February 23, 2015

## **National Park Service General Comments on the Desert Renewable Energy Conservation Plan (DRECP) Draft Environmental Impact Statement (EIS) and Supporting Documents**

National Park Service Comments on the Desert Renewable Energy Conservation Plan Draft Environmental Impact Statement – February 2015

Figure 1. Bighorn sheep habitat linkage in the Soda Mountain Area, as identified by Crech et al. (2014).

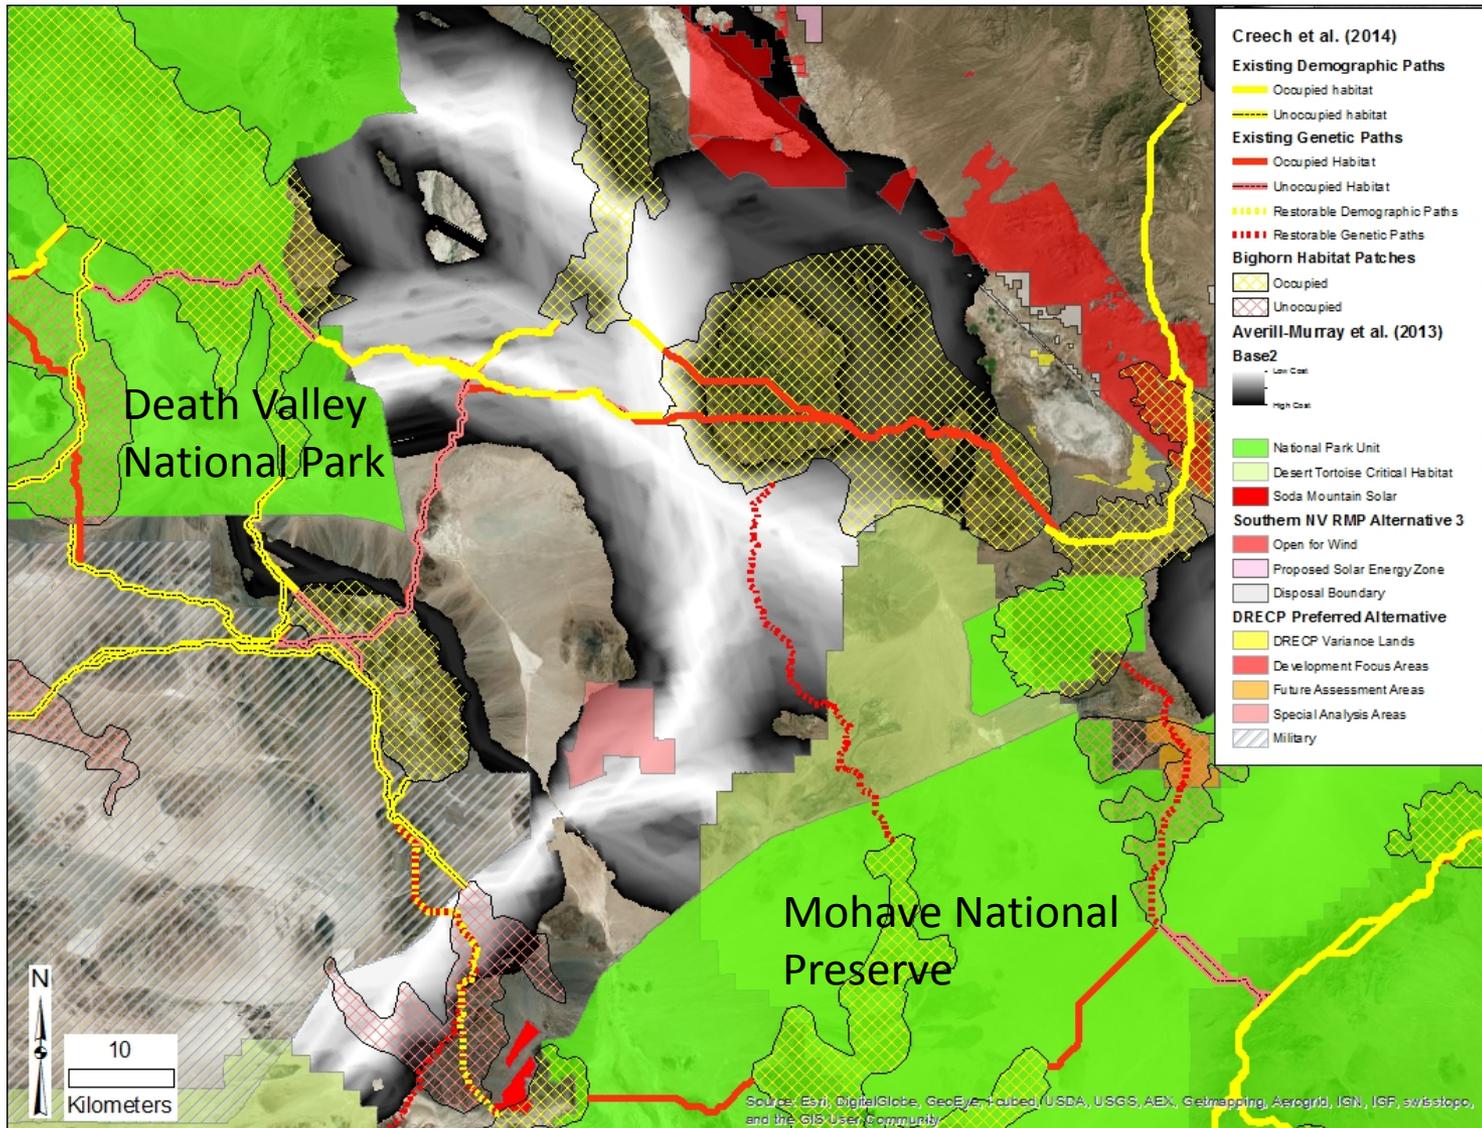
177.	II	II	2.3		Figure II.3-1	<p>Although the new protections through the Clark and Kingston Mountains area will be beneficial in the Preferred Alternative for habitat connectivity between Mojave National Preserve and Death Valley National Park, the proposed protection is likely to be inadequate for desert bighorn sheep. Recent work by Creech et al. (2014) confirms California Department of Fish and Wildlife biologist judgment decades ago that the Soda Mountain area is a crucial habitat linkage, currently disrupted by Interstate 15, between the metapopulation segments to the north and south of the freeway (see Figure 1). Creech et al. (2014) found four potentially restorable habitat linkages across I-15, three of which are genetic (meaning movement of rams only) while only one at Soda Mountain is demographic (meaning movement of both ewes and rams). The DRECP Preferred Alternative provides insufficient protection to this high priority restorable demographic linkage for bighorn sheep at Soda Mountain since the area to the south of I-15 at Soda Mountain is left undesignated. There is a potentially restorable genetic linkage that crosses from the Mescal Range northwards towards Clark Mountain, but this linkage is left unprotected (and potentially impacted) by the Future Assessment area in the north end of the Mescal Range. Thus the protections provided by the DRECP alternative for habitat connectivity between Mojave National Preserve and Death Valley National Park would be limited to a single potentially restorable genetic corridor that runs from Halloran summit north of Baker to the Kingston Range. To effectively restore demographic connectivity between the metapopulation segments to the north and south of the freeway, the NPS recommends ACEC or NLCS designation for the Soda Mountain area in the DRECP.</p> <p>Creech, T.G., C.W. Epps, R.J. Monello, and J.D. Wehausen, 2014. Using network theory to prioritize management in a desert bighorn sheep metapopulation, Landscape Ecology DOI 10.1007/s10980-014-0016-0.</p>

Figure 2. Desert tortoise habitat connectivity among National Park Service units identified in Averill-Murray et al. (2013).

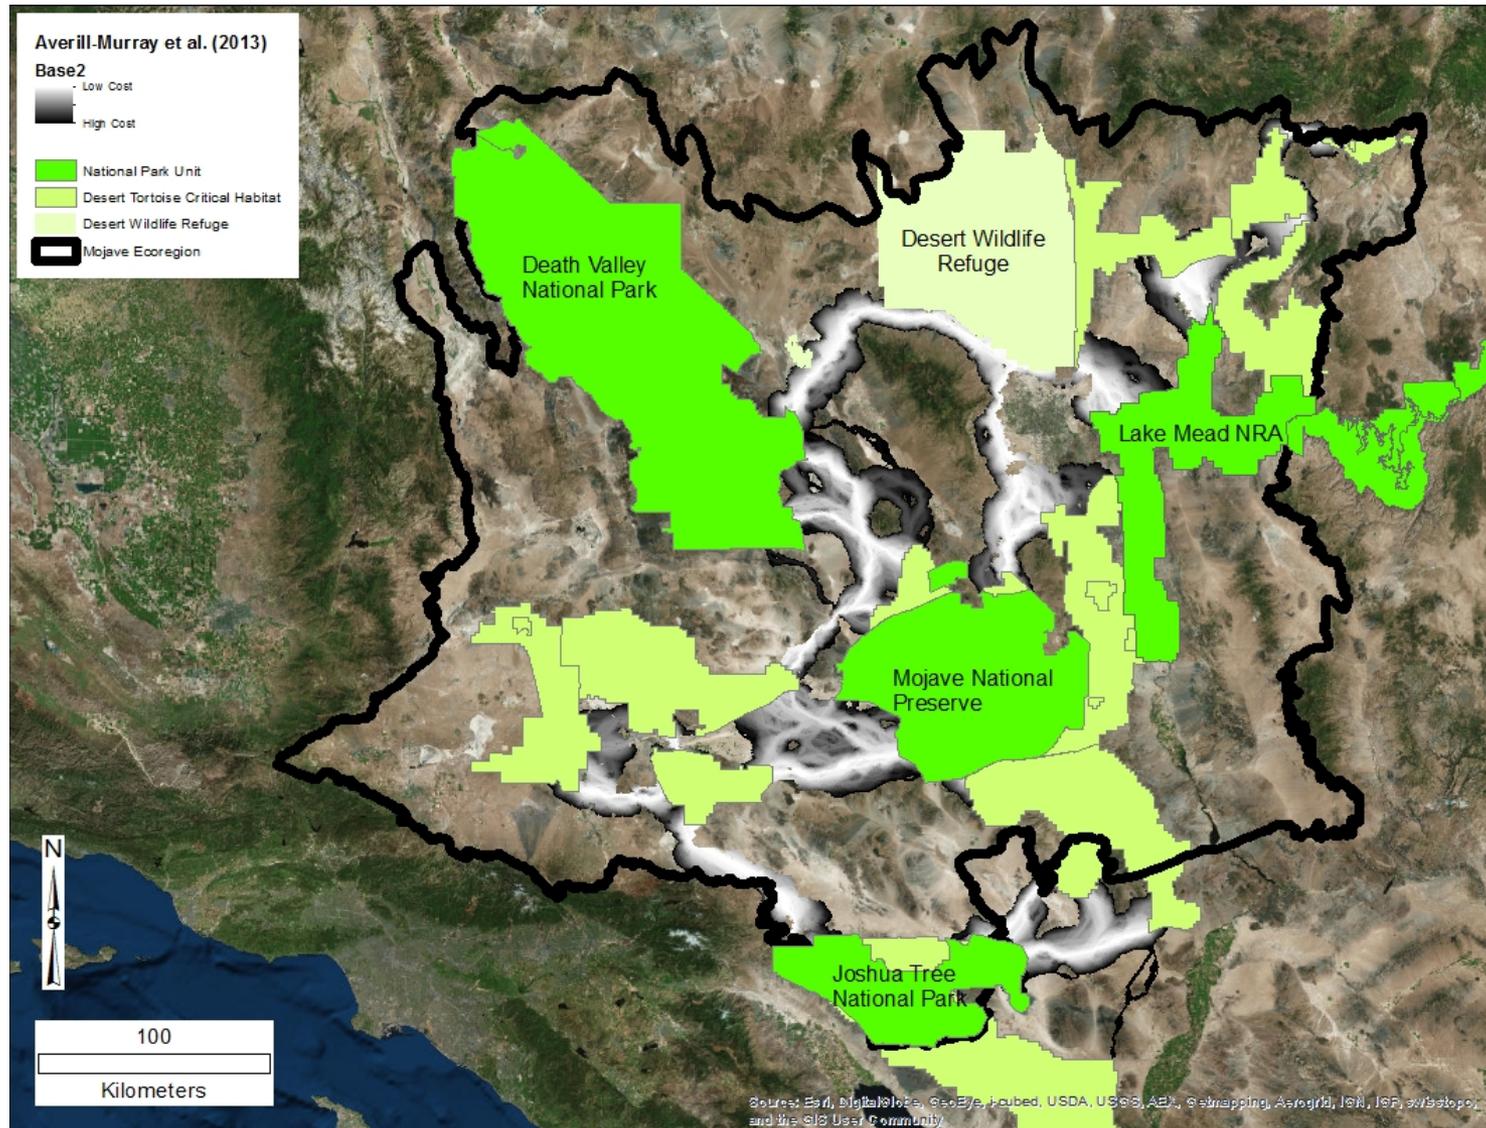
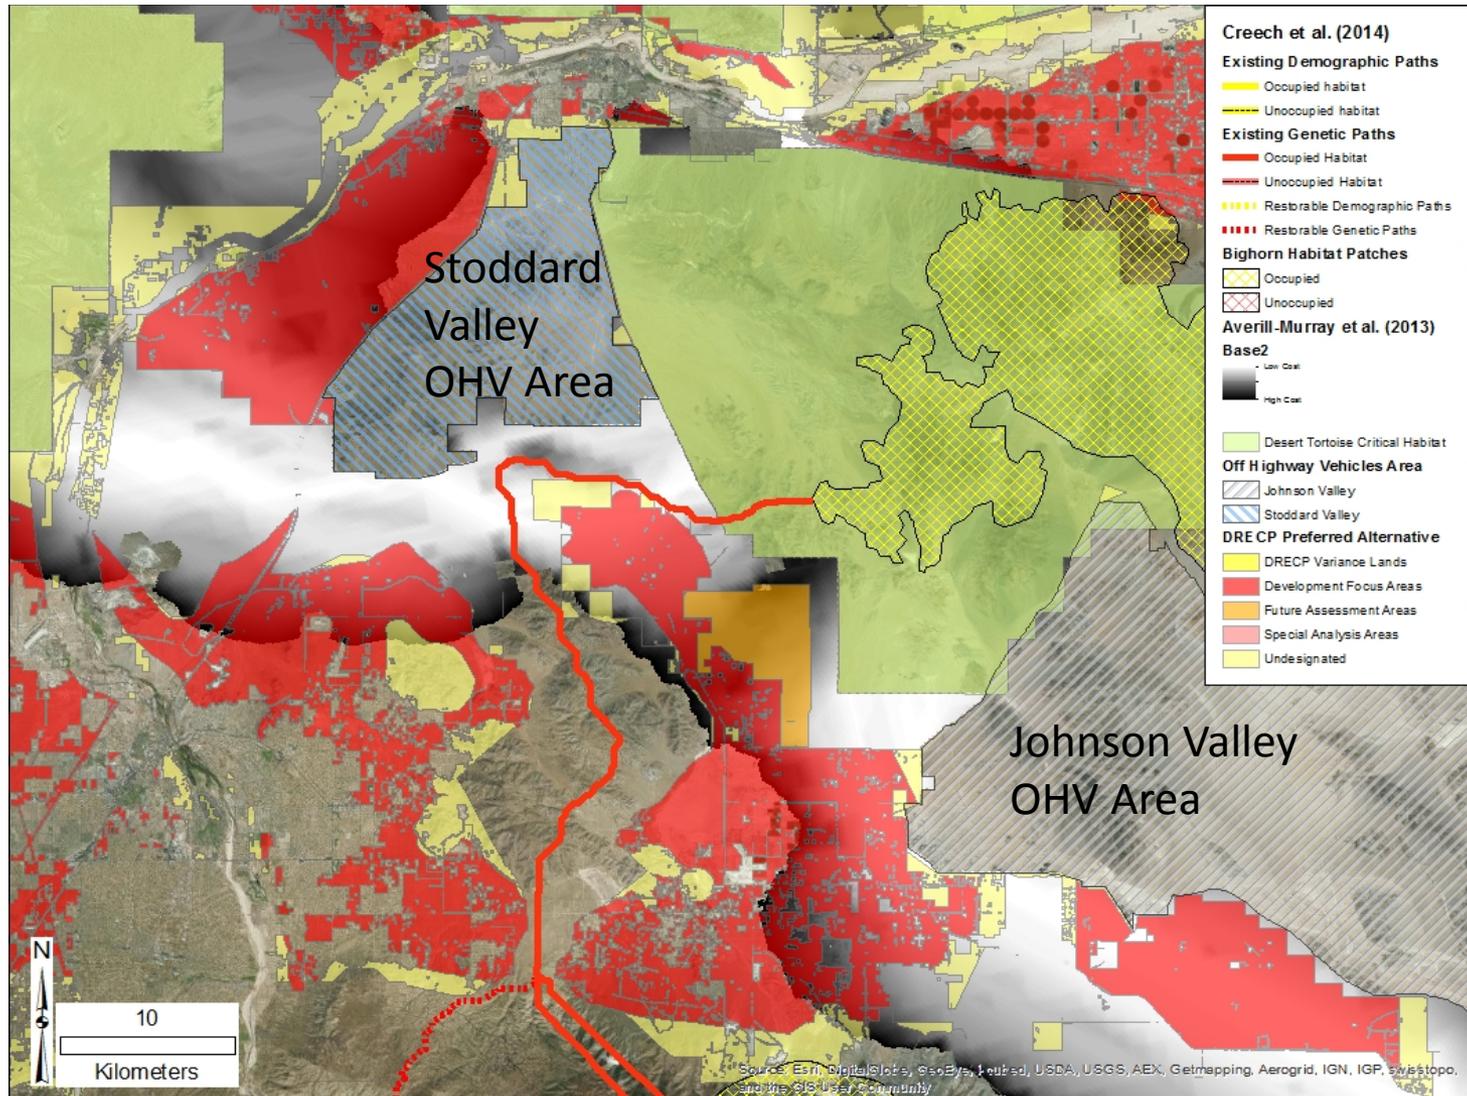
178.	II	II	2.3		Figure II.3-1	<p>Averill-Murray et al. (2013) analyzed least-cost corridors for desert tortoise habitat connectivity (see Figures 2 and 3). Connectivity from south to north exists both on the east and west sides of Joshua Tree National Park. Connectivity from the west side of the Park links the Pinto and Ord-Rodman Desert Wildlife Management Areas (DWMA). Northward connectivity also exists between the Ord-Rodman DWMA and Mojave National Preserve. South to north habitat connectivity might become increasingly important with advancing climate change. The DRECP Preferred Alternative provides protection to the linkage between Mojave National Preserve and the Ord-Rodman DWMA, but the utility of this linkage could be diminished if the corridor through Lucerne Valley linking Pinto and Ord-Rodman is blocked by energy development. Development on the desert tortoise corridor that runs through Lucerne Valley could leave only south to north connectivity on the east side of Joshua Tree National Park in the Mojave Desert for conservation of the desert tortoise. The NPS recommends further analysis of the Future Assessment Area and the potential effects on this desert tortoise connectivity.</p> <p>Averill-Murray, R. O. Y. C., Darst, C. R., Strout, N., &amp; Wong, M., 2013. Conserving population linkages for the Mojave Desert Tortoise (<i>Gopherus agassizii</i>). Herpetological Conservation and Biology, 8(1), 1-15.</p>
